**SSD-20724880 – Build to Rent Development at 30-46 Auburn Road, Regents Park  
Submission to the State Significant Development Application – Canterbury  
Bankstown Council**

### **State Significant Development Application SSD-20724880 – 30-46 Auburn Road, Regents Park Canterbury Bankstown Council Submission**

**Figure 3: Structure Plan**

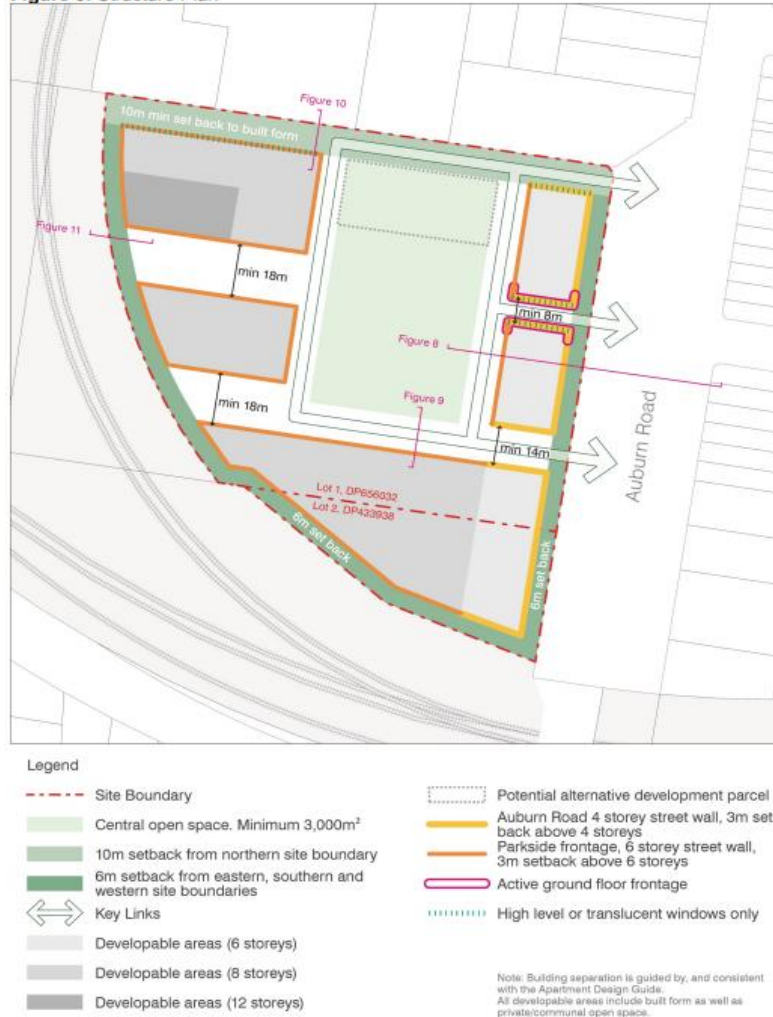
Further, it states that any variation from the building footprints and heights shown in Figure 3 must demonstrate that it achieves a higher quality outcome in terms of the Key Design Principles, including:

Based on Council's assessment of the SSD Application, we consider the proposal in its current form does not achieve consistency with these Key Design Principles for the following reasons:

- Any central open space on the site may be further impacted by overshadowing as a result of additional height;

### **Residential General Waste Chute System and Waste Rooms**

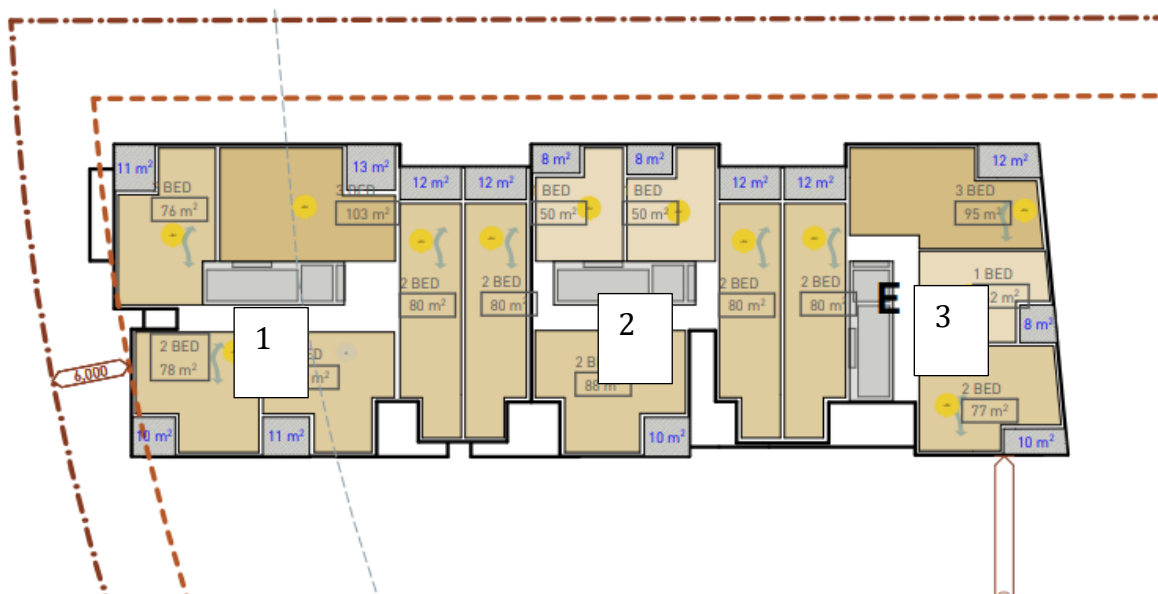
All buildings are to include waste rooms on each level, for the co-location of general waste, recycling and garden organic facilities. The concept architectural plans indicate that there are sections on each level, the image below shows Level 2 Building E with three sections.

These sections will impact the number of rooms required, as the maximum travel distance from each unit to the waste room is 30m. Therefore having sections requires a waste room to be located next to each lift on each level. If the sections are removed and each level has a central lift and foyer, one waste room per level is needed.
